RE: RAWP Addendum #6 – Temporary SVE System Effluent Discharge
737 4th Avenue, Brooklyn, NY
BCP #C224332

P.W. Grosser Consulting Engineer & Hydrogeologist, P.C. (PWGC) has prepared this addendum to the New York State Department of Environmental Conservation (NYSDEC)-approved Remedial Action Workplan (RAWP), dated February 2023, for the above-referenced site (the Site). The purpose of this RAWP Addendum #6 is to document the proposed location of the soil vapor extraction (SVE) system's temporary effluent discharge location.

CELLAR SUB-SLAB DEPRESSURIZATION (SSDS) AND SOIL VAPOR EXTRACTION (SVE) PLAN
SCALE: 1/8" = 1'

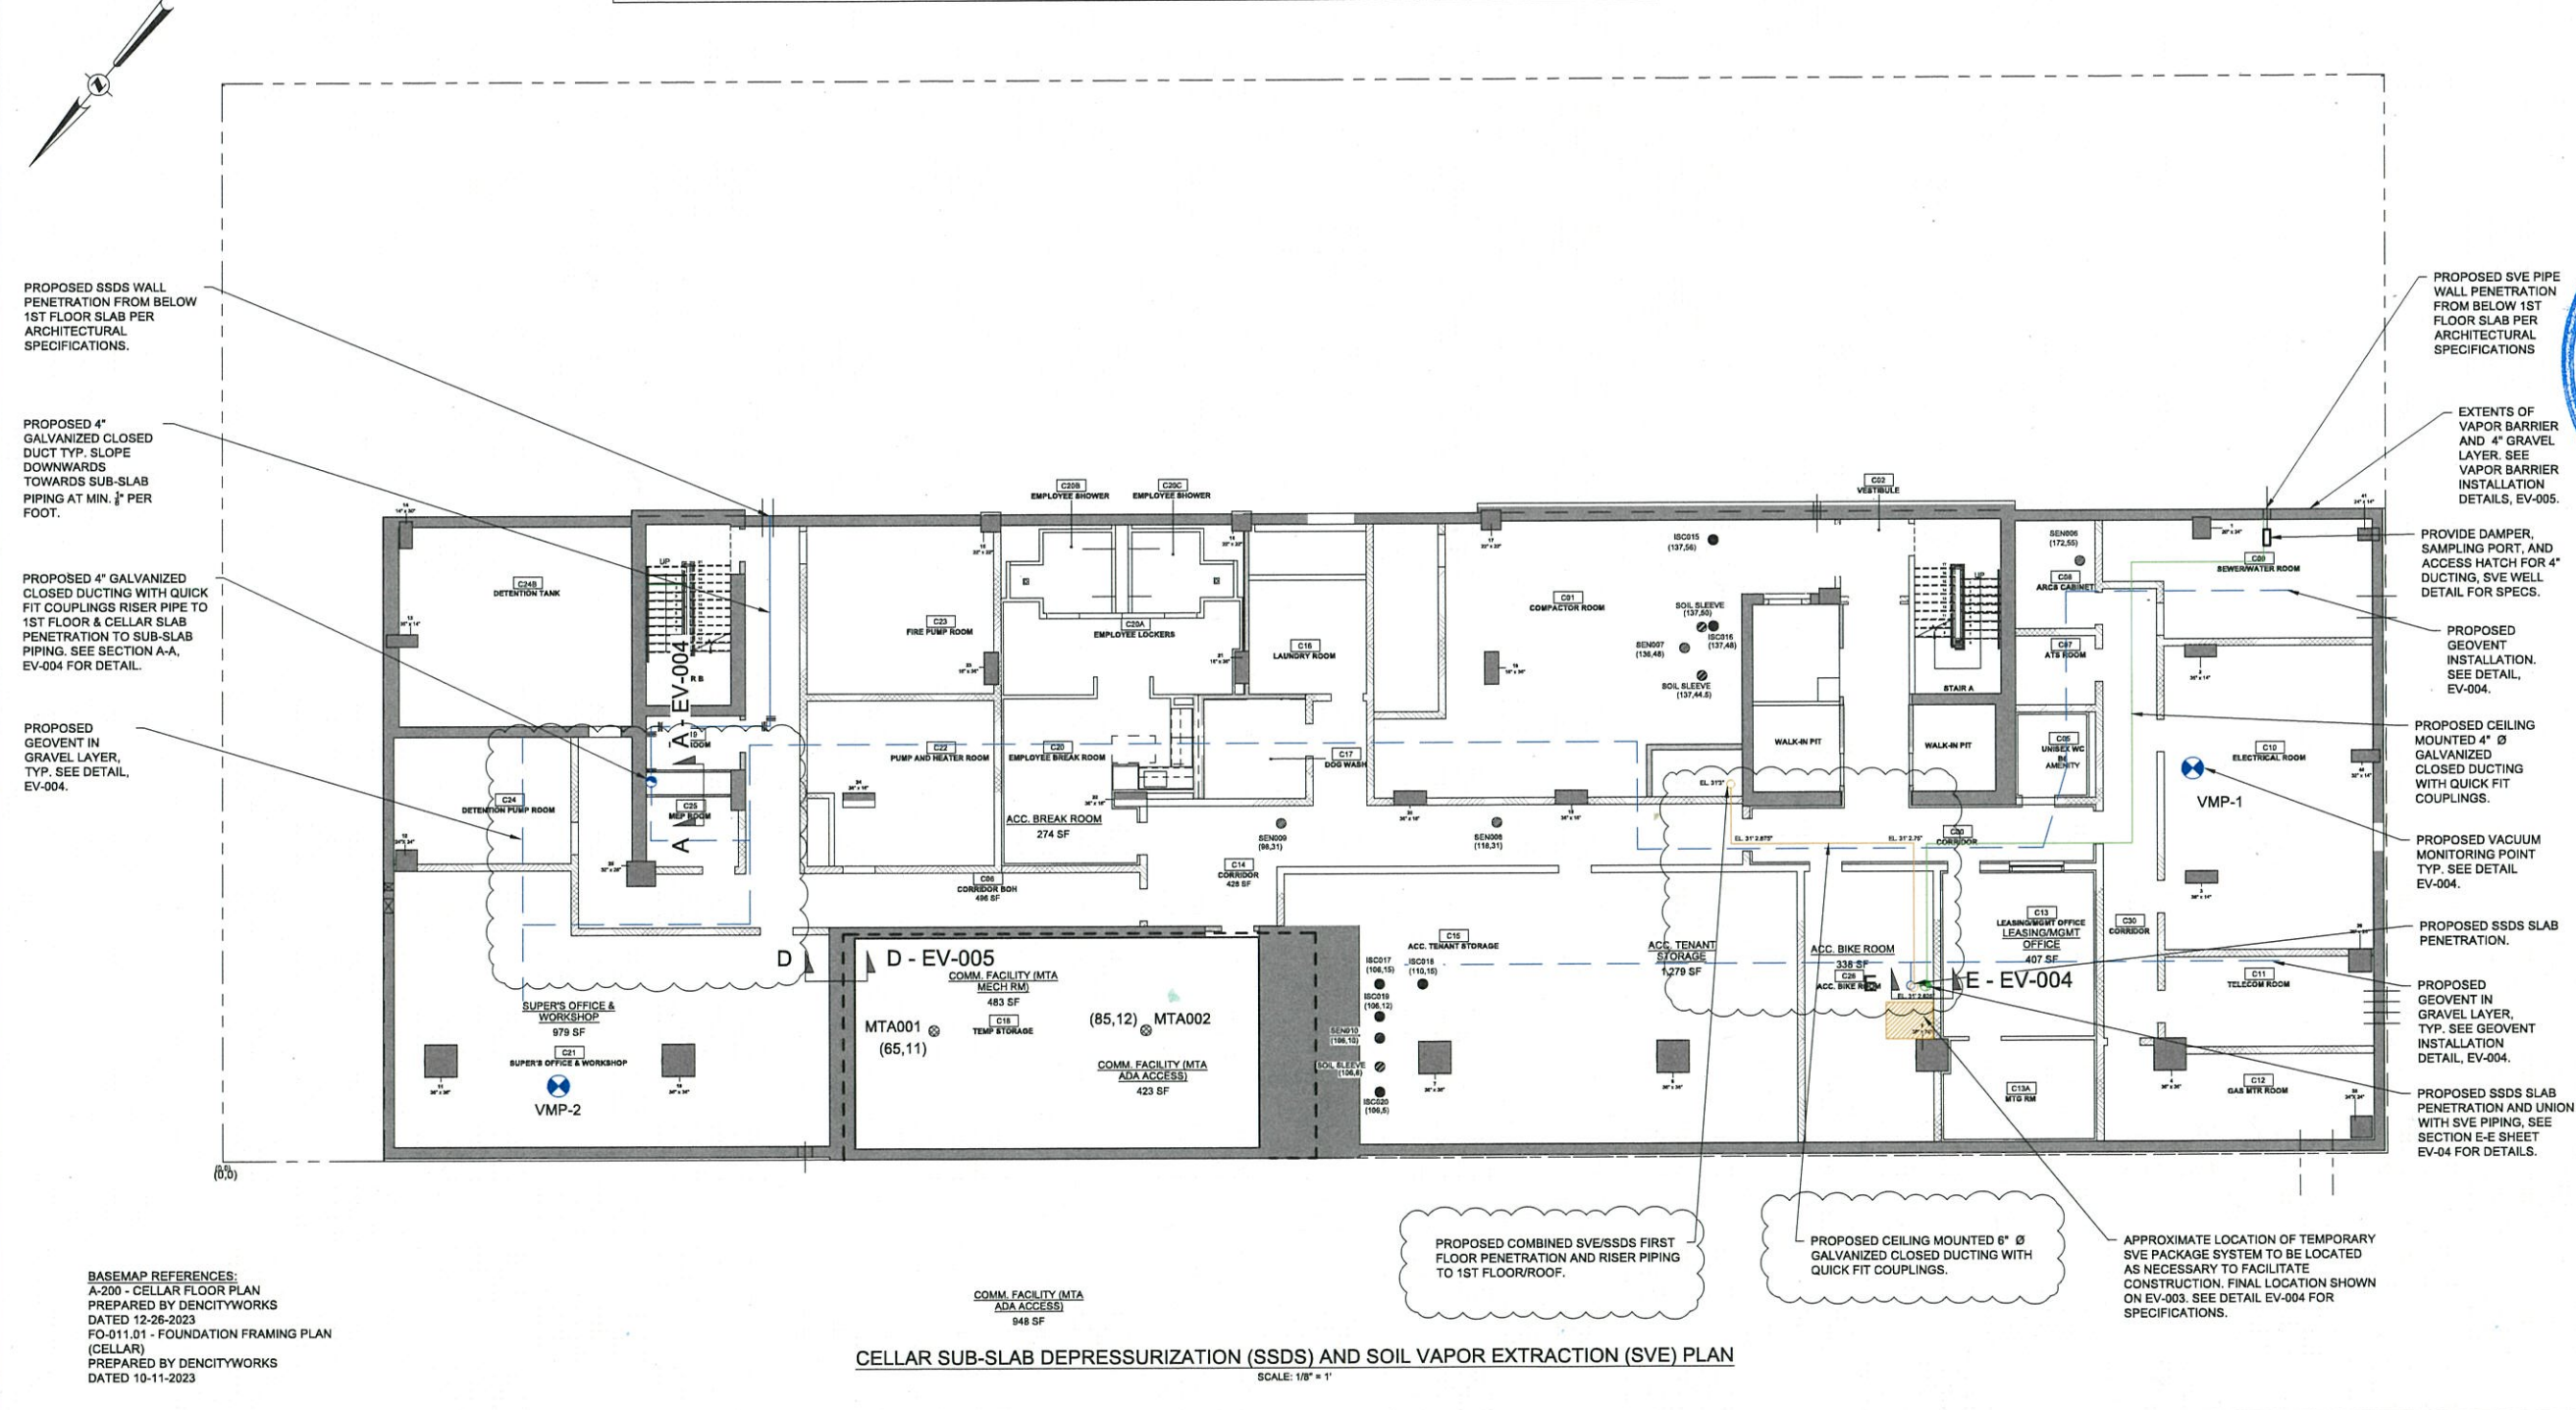
APPROXIMATE LOCATION OF TEMPORARY SVE PACKAGE SYSTEM TO BE LOCATED AS NECESSARY TO FACILITATE CONSTRUCTION. FINAL LOCATION SHOWN ON EV-003. SEE DETAIL EV-004 FOR SPECIFICATIONS.

1ST FLOOR SSDS & SVE PLAN
SCALE: 1/8" = 1'

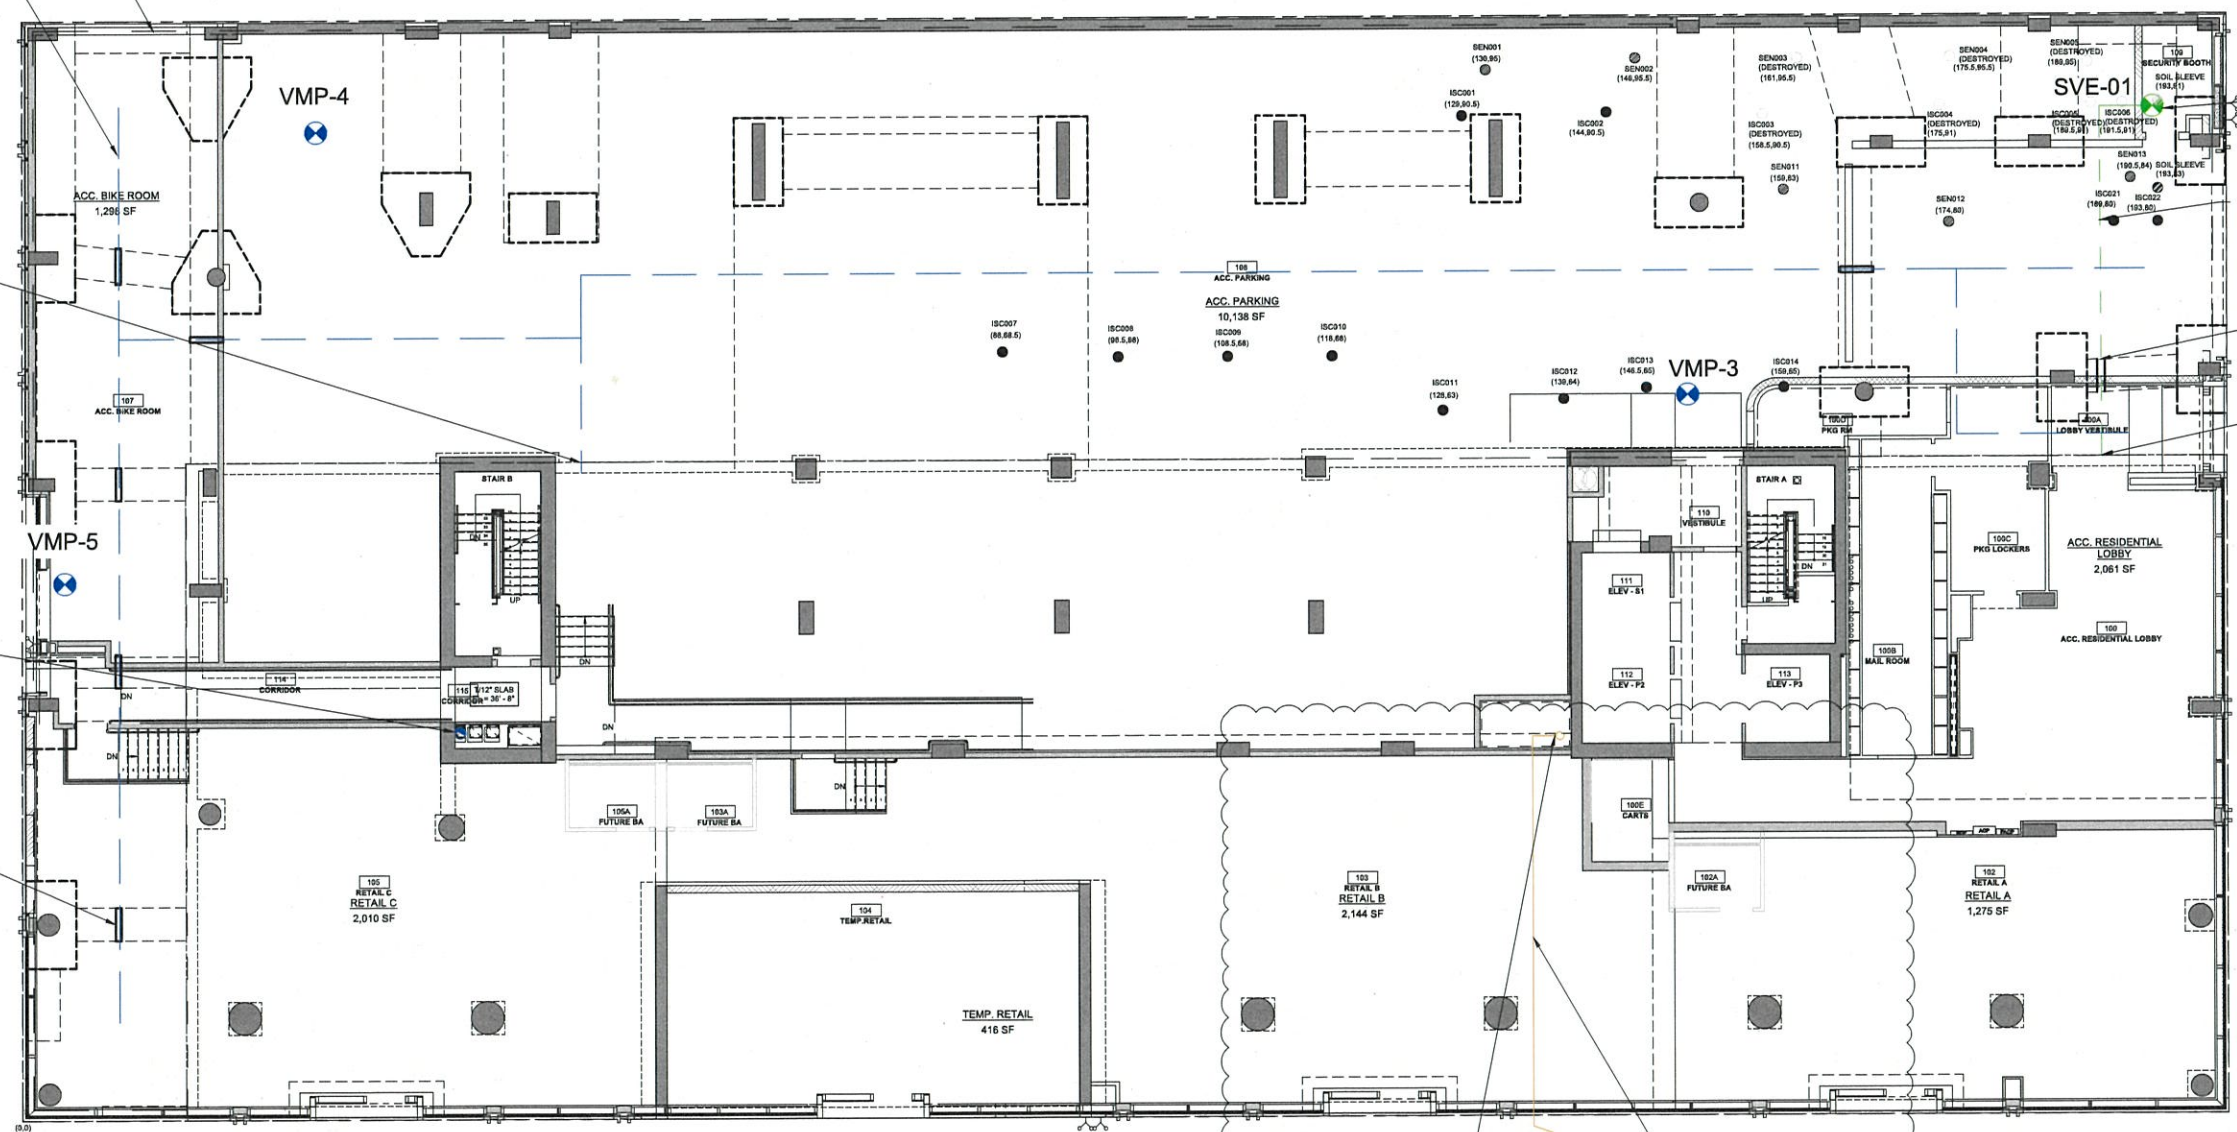
COMBINED SVE/SSDS PIPING FIRST FLOOR PENETRATION
TEMPORARY SVE EFFLUENT DISCHARGE. SEE DETAIL ON EV-006
PROPOSED CEILING MOUNTED 6" Ø GALVANIZED CLOSE DUCTING WITH QUICK FIT COUPLINGS, MAX 12' SPACING

SVE DISCHARGE PIPE DETAIL
SCALE: NOT TO SCALE

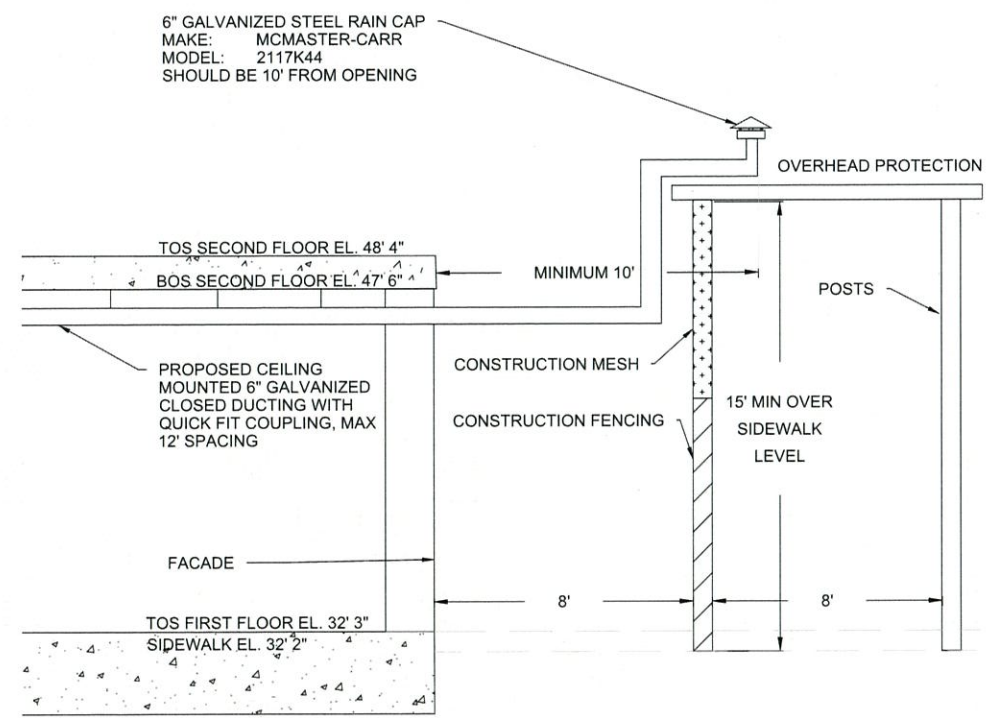
The permanent installation of the SVE system will occur, if needed, after the building superstructure has been completed. As the site is pursuing a Certificate of Completion (COC) for 2024, a temporary installation has been proposed that will place the SVE system in the basement and the effluent discharge routed towards 4th Avenue at approximately the height of the second floor. The temporary effluent discharge piping will be secured to the ceiling of the first floor and will then be routed west outside of the building and over the top of the pedestrian scaffolding bridge. This will place the effluent discharge a minimum of 10 feet from the building openings and approximately 15 feet above the sidewalk level. As a reminder, the SVE system has two carbon drums to treat the effluent prior to discharge.
